General machining tolerances UNI 5307-63								
Dimensions	< 6	>6-30	>30-120	>120-315	>315-1000	>1000-2000	>2000-4000	> 4000
linear Toll.	± 0.1	± 0.2	± 0.3	± 0.5	± 0.8	± 1.2	± 2	± 3
angular Toll.	± 1	± 30'	± 20'	± 10'				referred to the shortest side
designed for		R.De Salvo						
draw. by		G.Gennaro-PROMECC						
date		16-10-06		scale		1/1		
title		HAM OPTICAL BENCH						
		ELEVATOR						
detail from		194		A		2

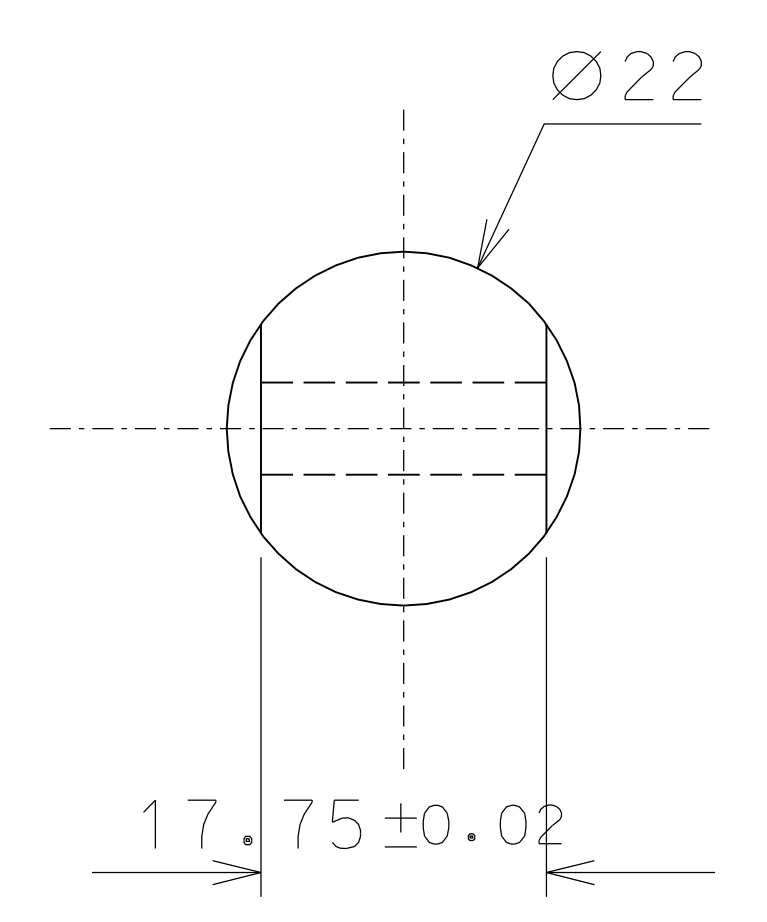
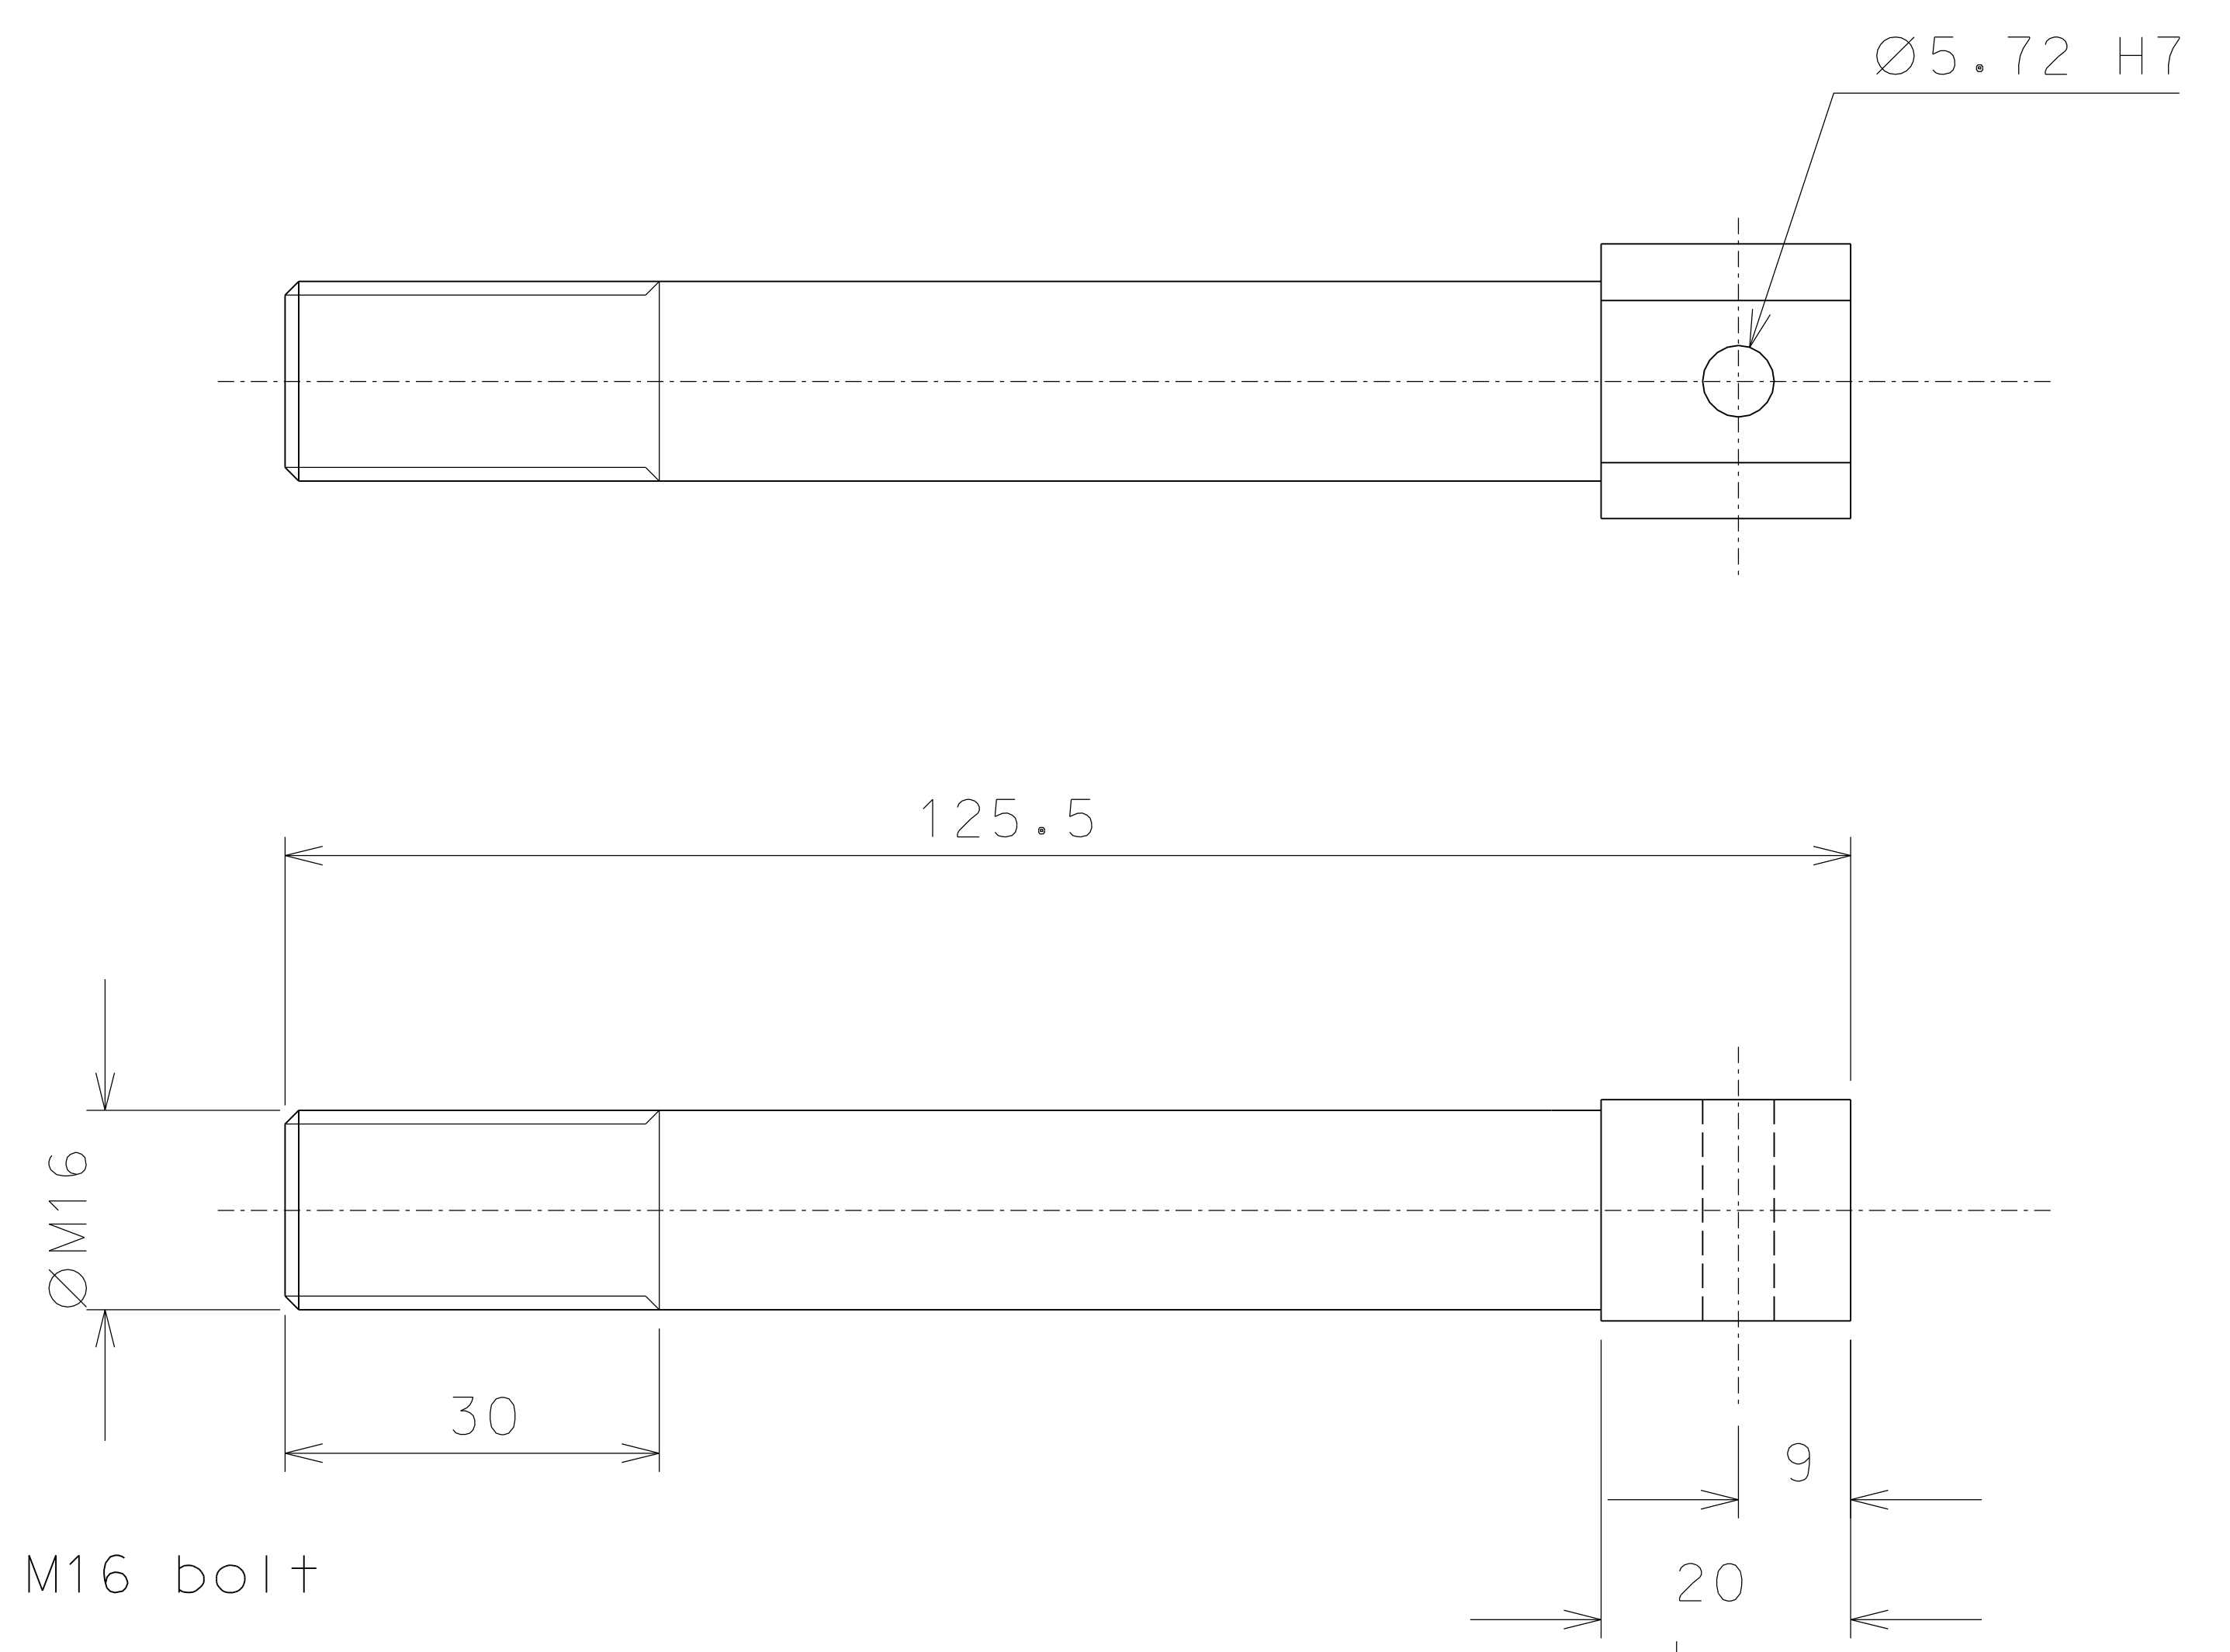
use stainless steel M16 bolt

use M12 bolt

use stainless steel M16 bolt
